REMARKS

On February 21, 2001, Applicant filed an Amendment (the "Prior Amendment") to a prior Office Action (the "Prior Office Action") dated August 21, 2000. In the Office Action of May 8, 2001, the Examiner objected to the sufficiency of the Prior Amendment in response to an objection to the disclosure and to a rejection of claim 47 under 35 U.S.C. § 112, second paragraph. Responsive to the statements in the Official Action, Applicant has herein amended certain portions of the specification and claim 47.

B. Drawings

VERSION WITH MARKINGS TO SHOW CHANGES

FIG. 2

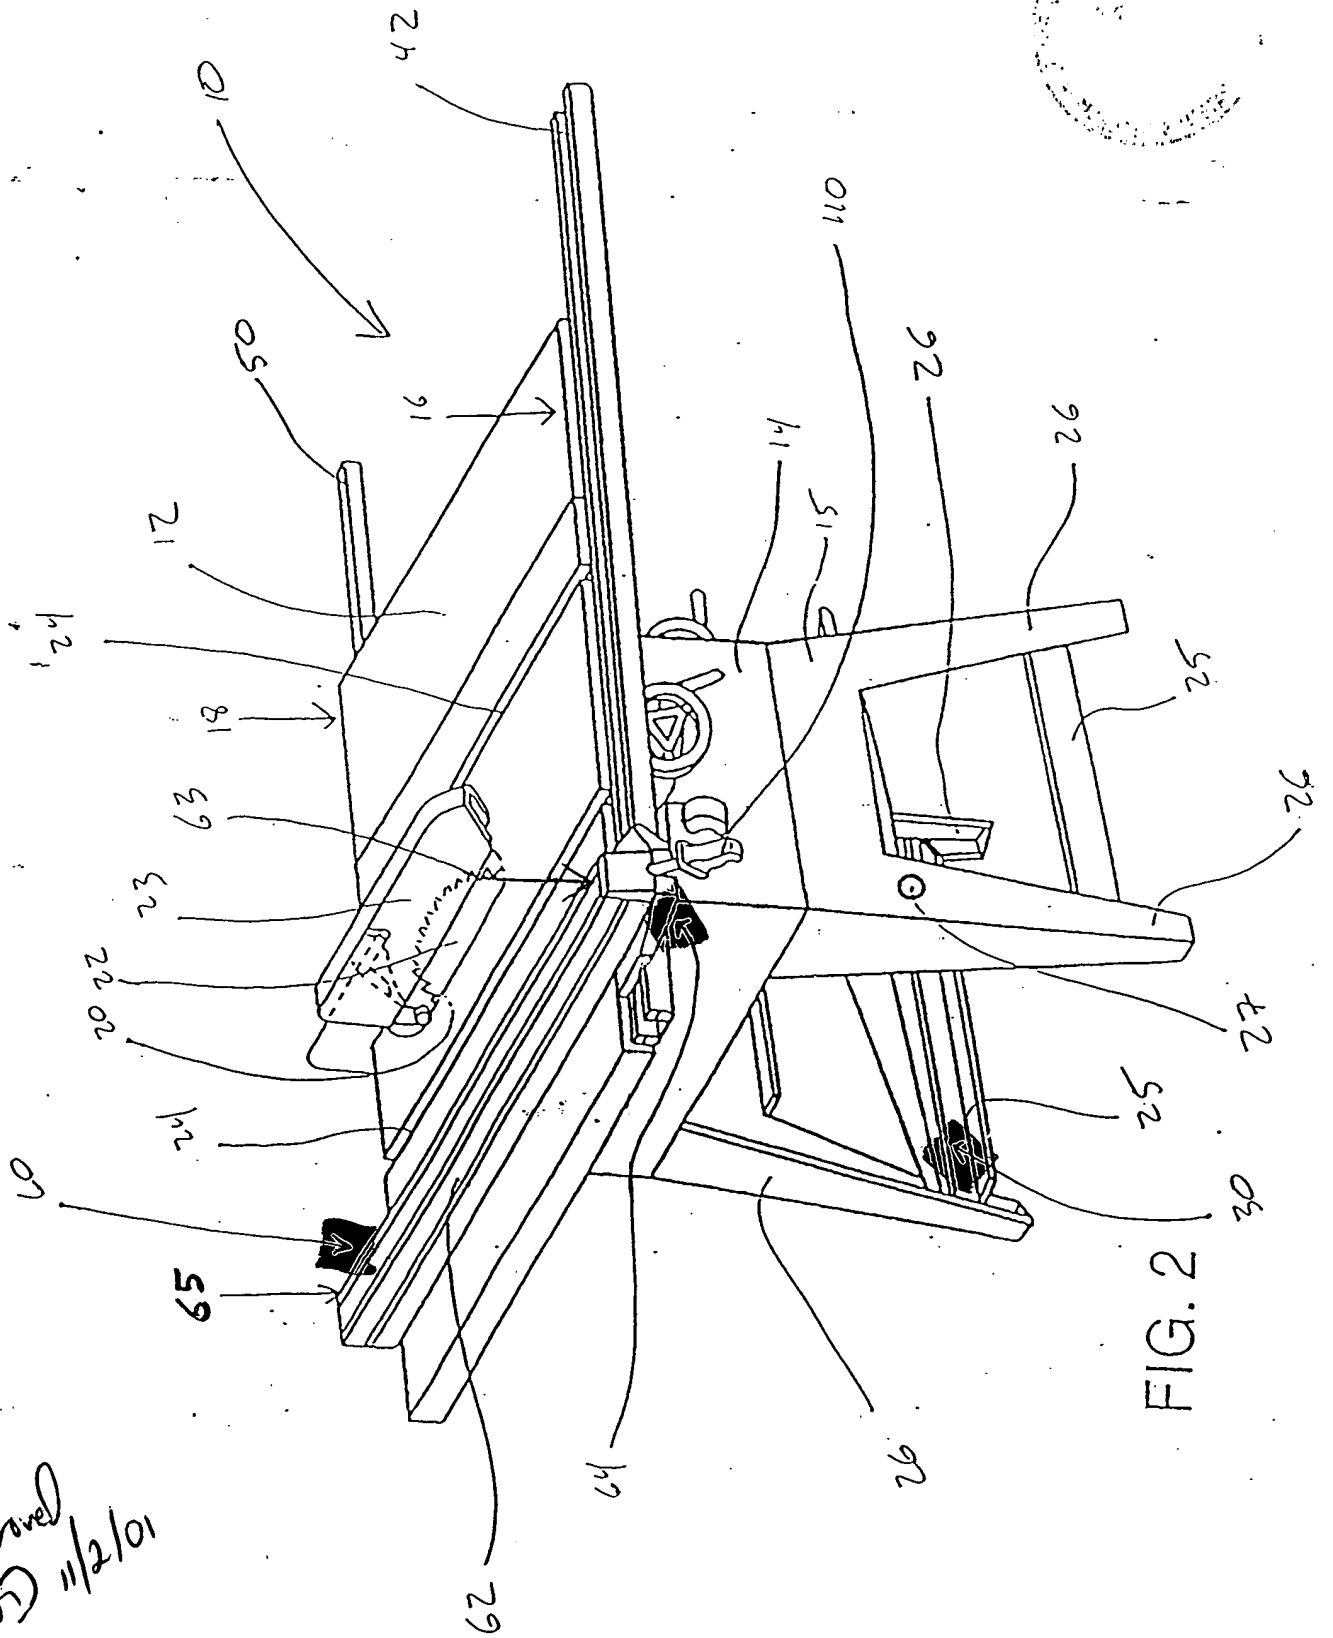
- Figure 2: Reference number "64" lead line amended to terminate with an arrow.
- Reference number "60" lead line amended to terminate with an arrow.
- Reference number "30" lead line amended to terminate with an arrow and redirected to point to proper element.

FIG. 4

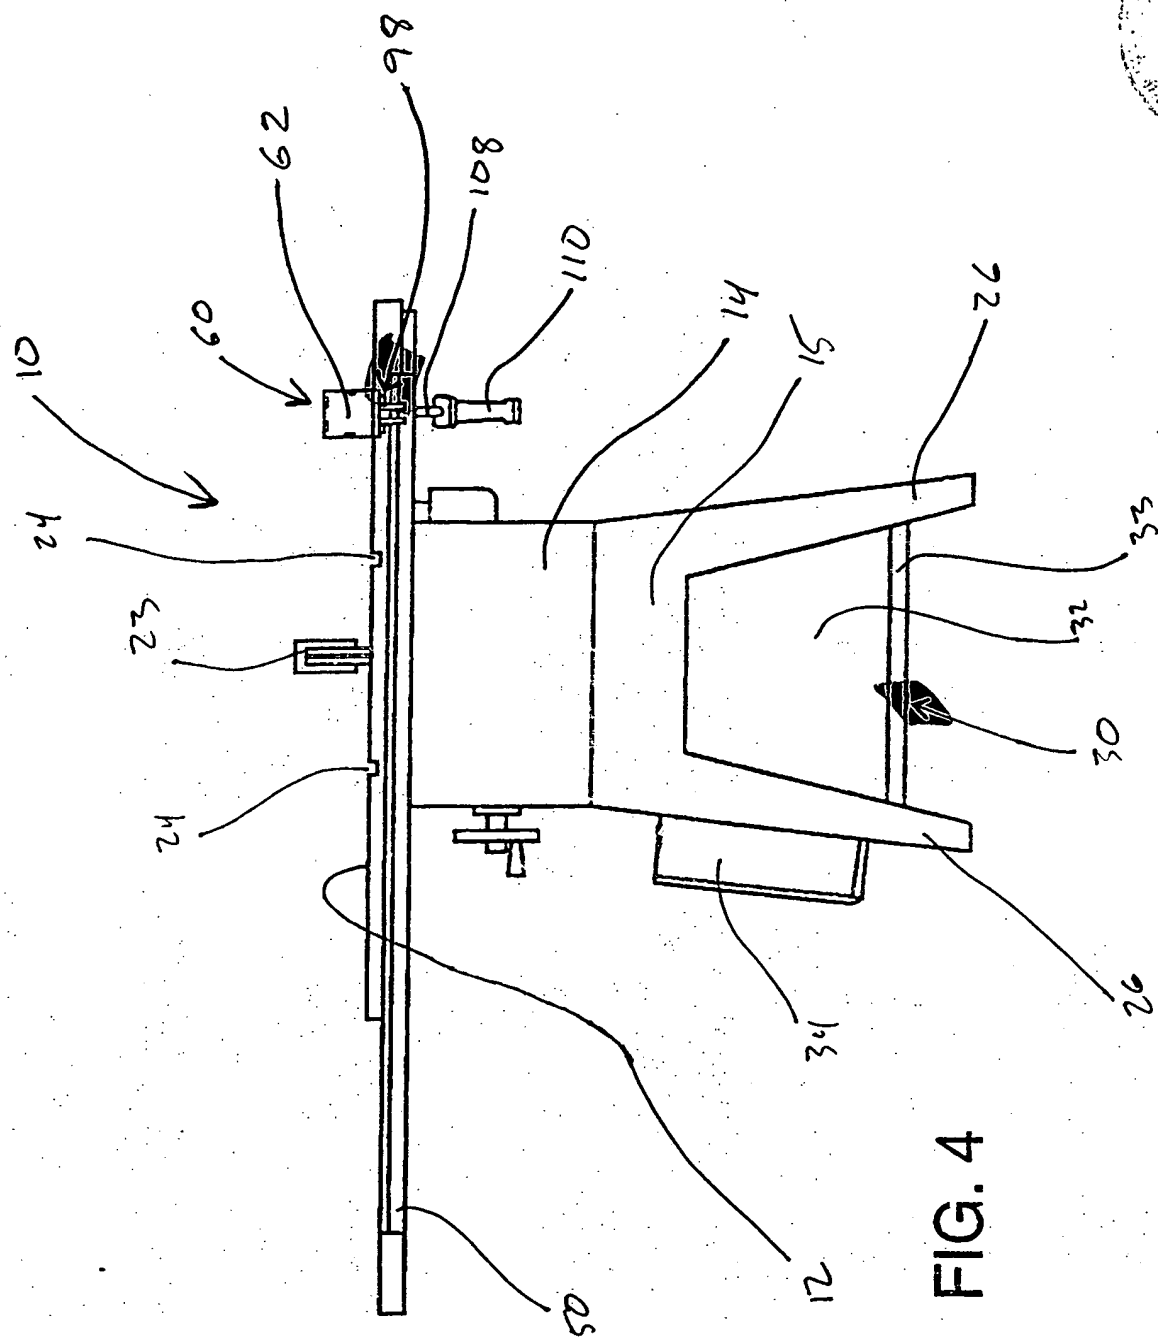
- Figure 3: Reference number "64" lead line amended to terminate with an arrow.  
Reference number "30" lead line amended to terminate with an arrow.
- Figure 4: Reference number "98" lead line amended to terminate with an arrow.  
Reference number "30" lead line amended to terminate with an arrow.

FIG. 5

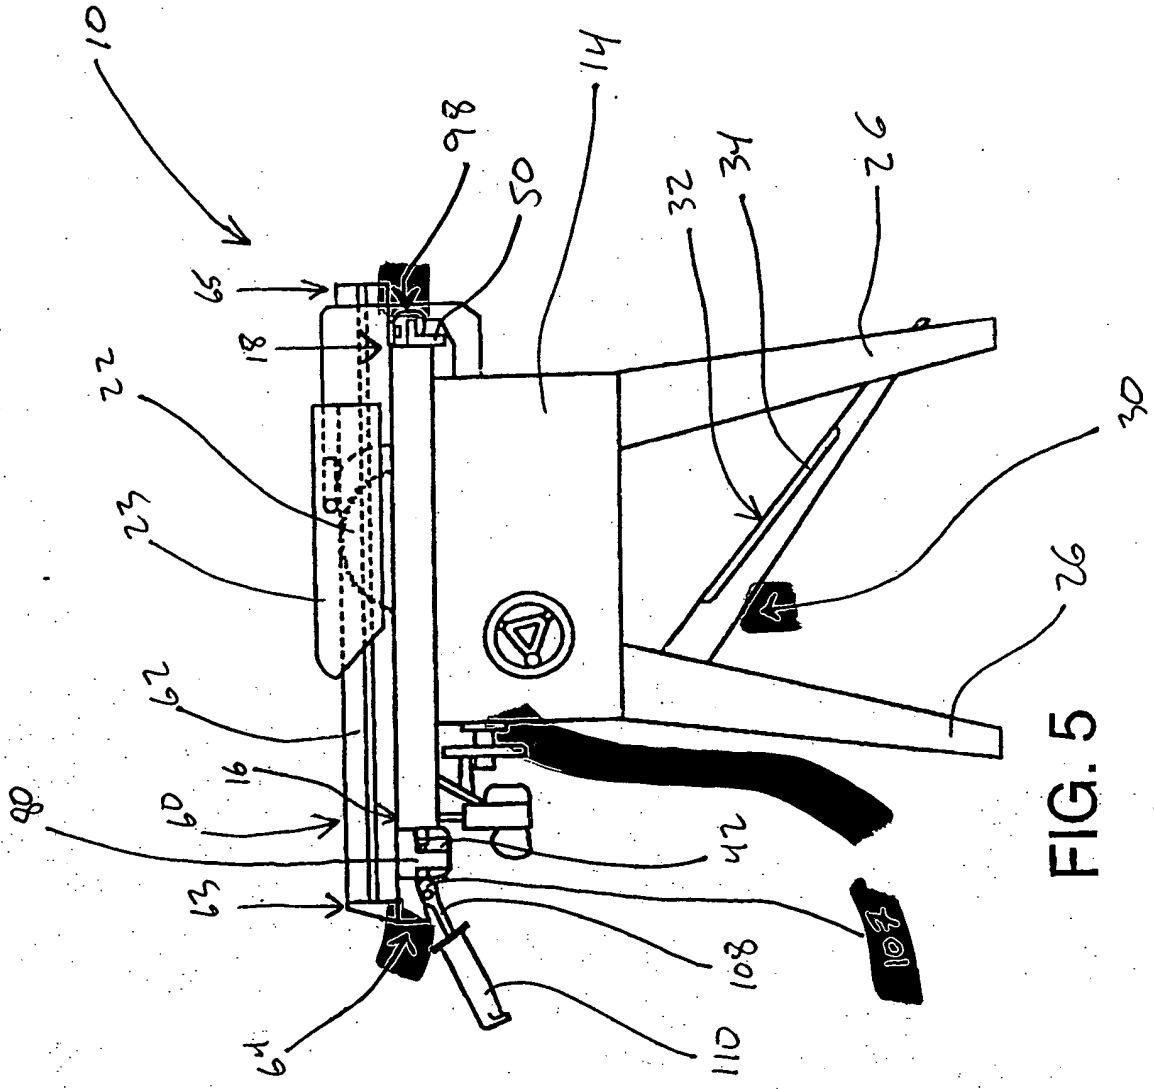
- Figure 5: Reference number "98" lead line amended to terminate with an arrow.  
Reference number "30" lead line amended to terminate with an arrow.  
Reference number "12" and reference number "12" lead line deleted.  
Reference number "105" replaced with reference number "107" to properly show the element.  
Reference number "64" lead line amended to terminate with an arrow.

Fig. 6

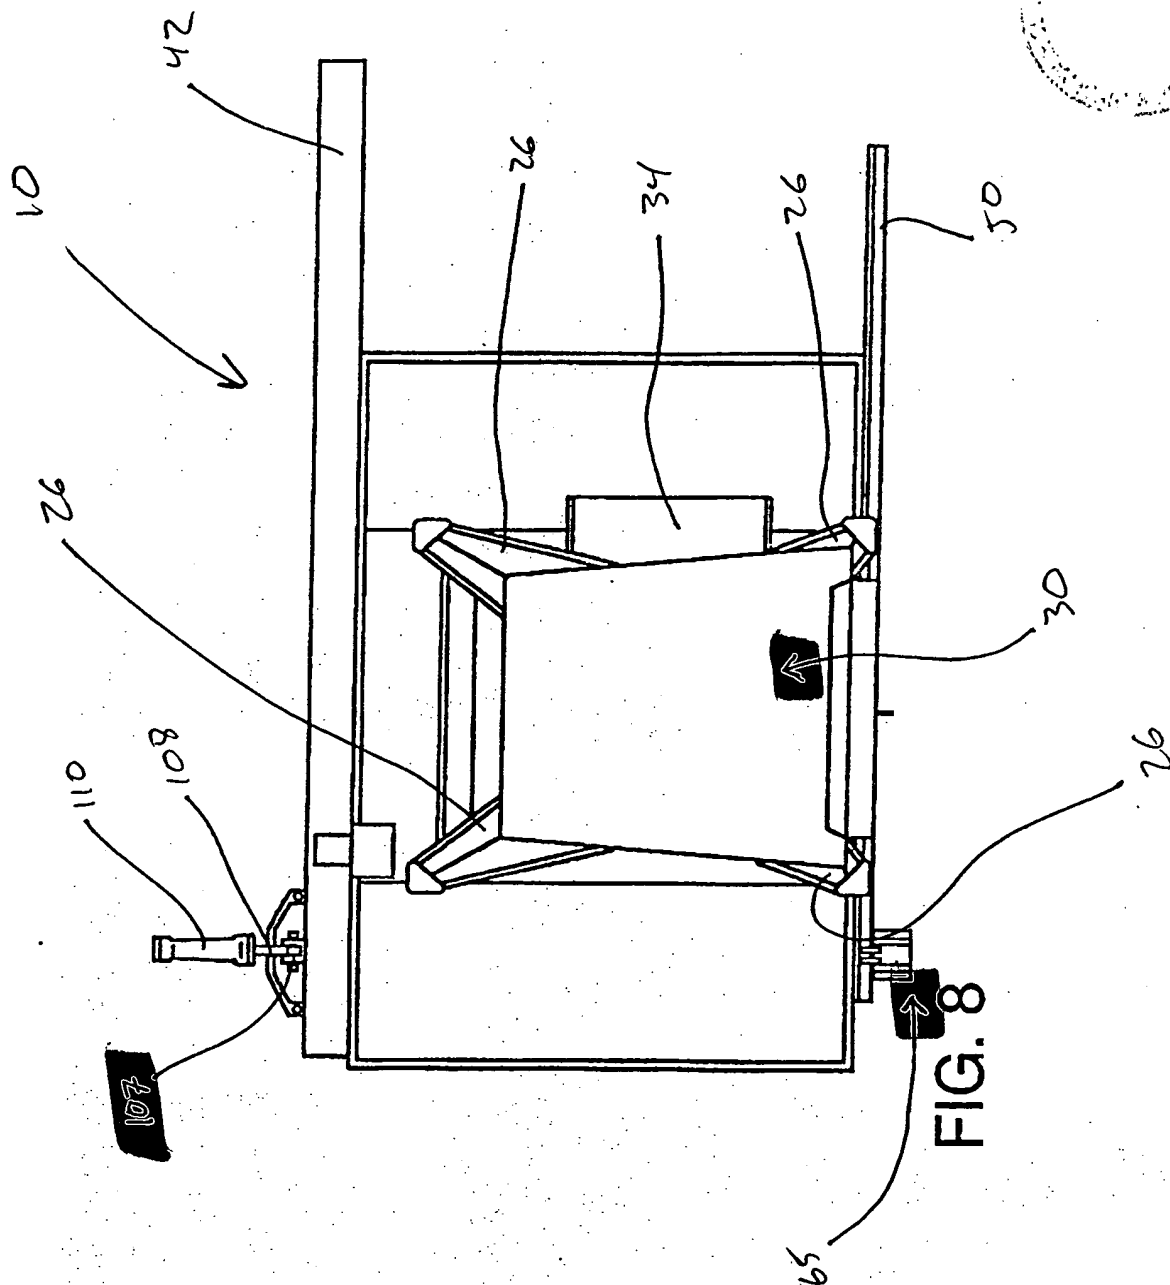
- Figure 6: Reference number "98" lead line amended to terminate with an arrow.  
Reference number "18" lead line redirected to point to proper element surface.  
Reference number "12" lead line redirected to point to proper element surface.  
Reference number "64" lead line amended to terminate with an arrow.  
Reference number "105" replaced with reference number "107" to properly show the element.  
Reference number "30" lead line amended to terminate with an arrow.

FIG. 13

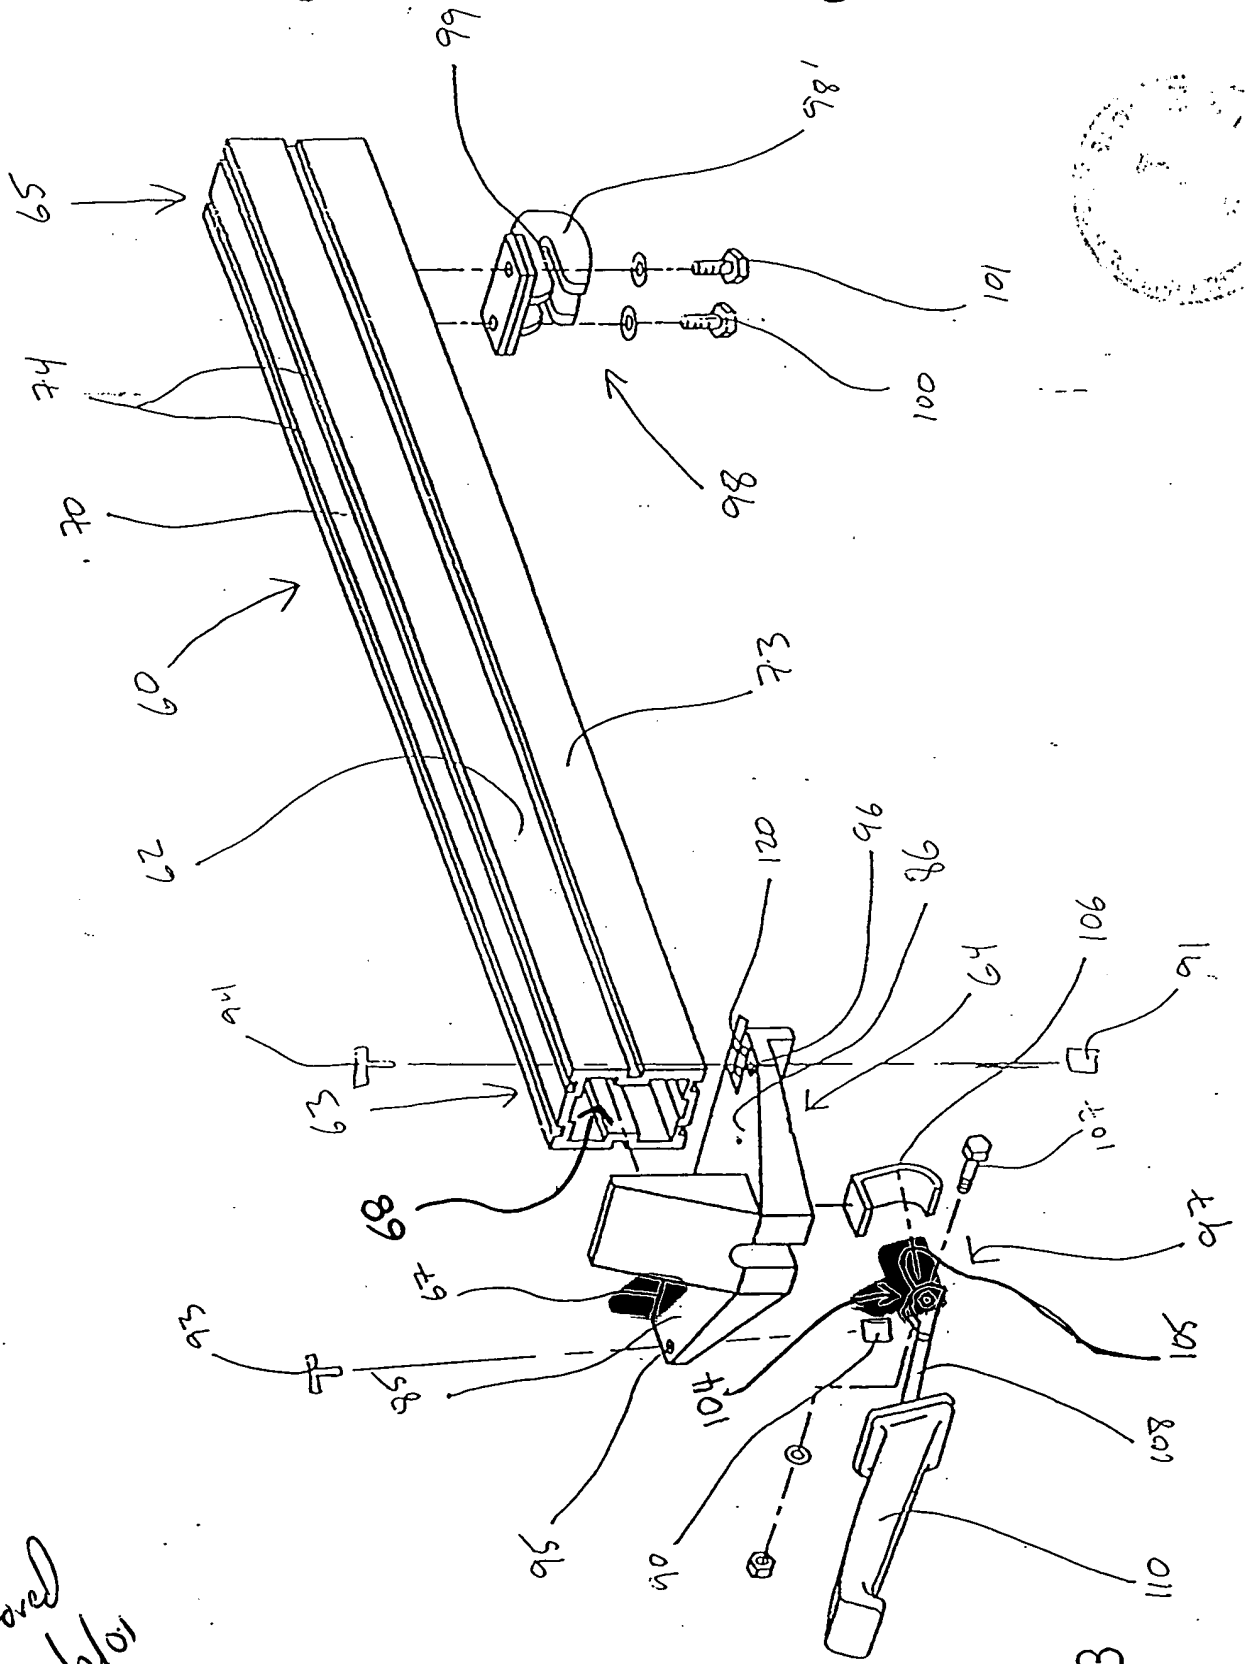
- Figure 13: Reference number "67" lead line amended to terminate without an arrow and redirected to point to proper element surface.  
Reference number "104" lead line amended to terminate with an arrow.  
Reference number "105" lead line amended to terminate without and arrow.

FIG. 14

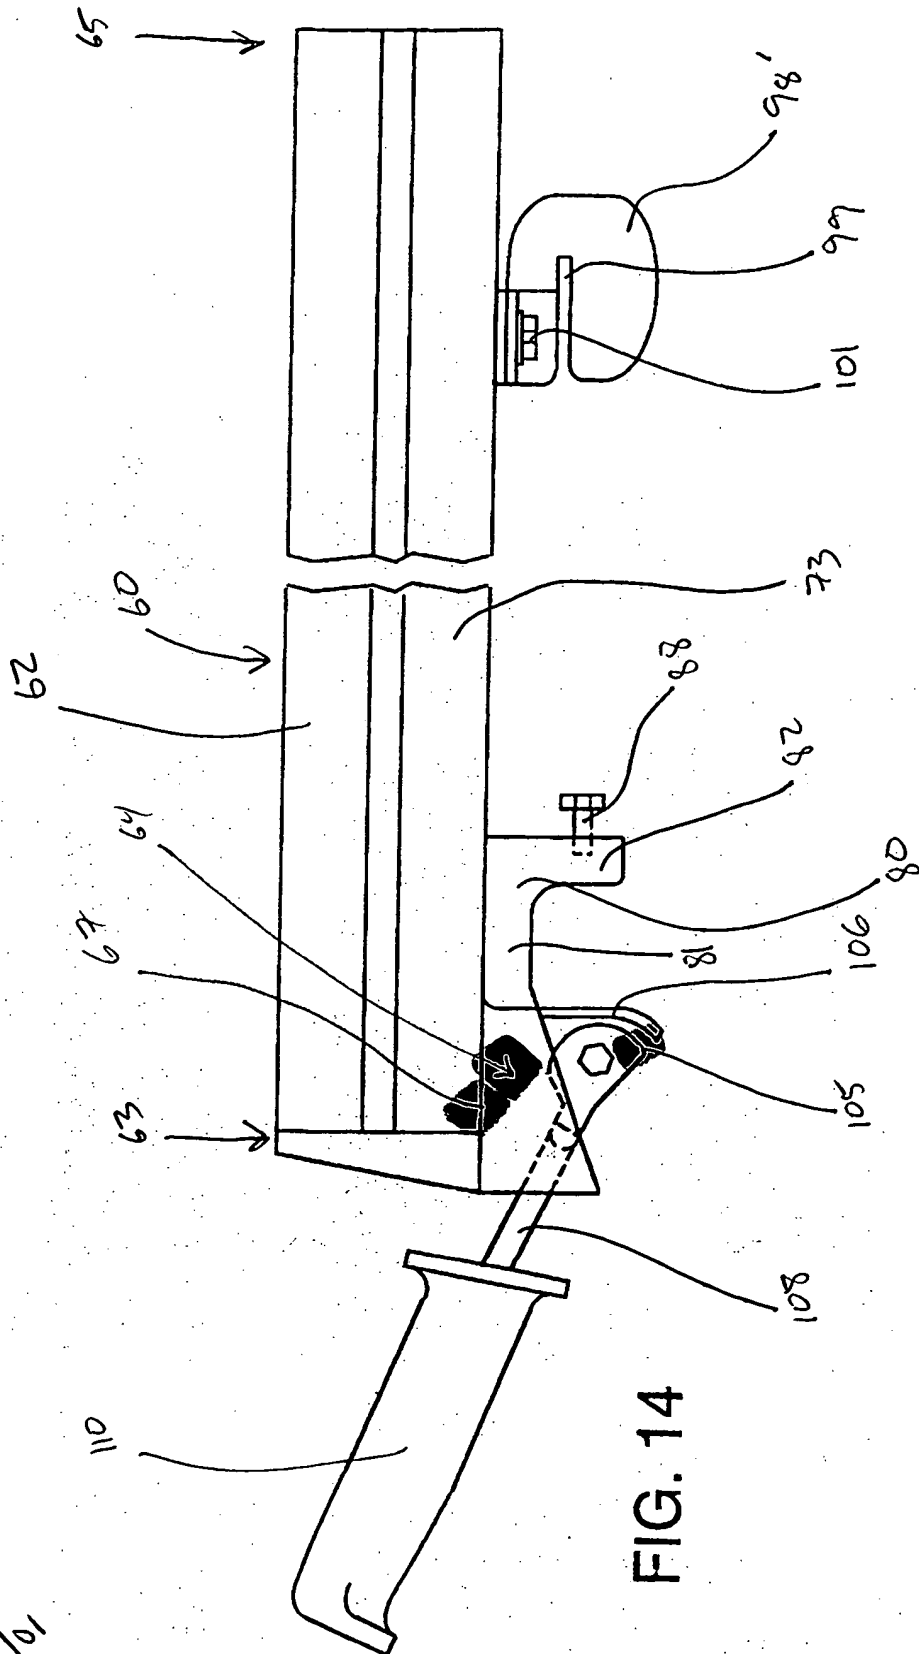
- Figure 14: Reference number "67" lead line amended to terminate without an arrow.  
Reference number "64" lead line amended to terminate with an arrow.  
Reference number "105" lead line redirected to point to the proper element surface.
